Customer Name:	**Gallien-Krueger**		Current Rev #:	A3	New ECO Rev #:	A4
Model:	400RB-IV		Distribute To:		Page: 1	Of: 1
Assembly Description:	Power Amp		Originator:	Enrique Hernandez		
Assembly Numbers:	206-0240-A		Approved by:			
	145-0240-A		Effective Date:	8/10/2005

Reason For Change

APPROVALS		TITLE:	
	INT	DATE	400RB-IV POWER AMP	
DESIGNER:	R.A.G.	11/9/99	DRAWING NO. 406-0240-A4	REV.
DRAWN:	R.A.G.	8/10/05		A4
ELEC:			PART NO. 206-0240-A4	
MECH:			COMPANY: GALLIEN KRUEGER	
Q/A:				
RELEASED:			FILENAME: 6240A3.sch

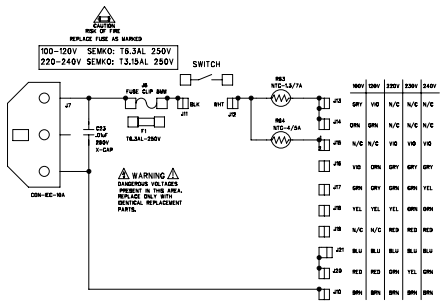
1. Q7(2SC3381) on power amp is obsolete, replace with two 2SC2240BL.

2. Remove R5, change values of R14 to 43.2K and C6 to 1uF, 50V. This is to decrease offset DC voltage from 45mVdc to 10mVdc.

NOTES REV A3:
1. REPLACE Q7 W/2SC3381 WITH TWO
   2SC2840BL (Q7A AND Q7B)
2. REMOVED R5.
3. CHANGE VALUE OF R14 FROM 12.1K TO 43.9K
4. CHANGE VALUE OF C6 FROM 10uF TO 1uF.

Part Number	Description	Parts Added		Parts Deleted	
		Qty	Ref. Designator	Qty	Ref. Designator
010-0000-0	2SC3381BL			1	Q7
010-0010-0	2SC2240BL	2	Q7, Q7A		
060-1213-0	12.1k RES, 1/8W			2	R5, R14
060-4323-0	43.2k RES, 1/8W	1	R14		
031-2106-0	CAP 10uF, 50V			1	C6
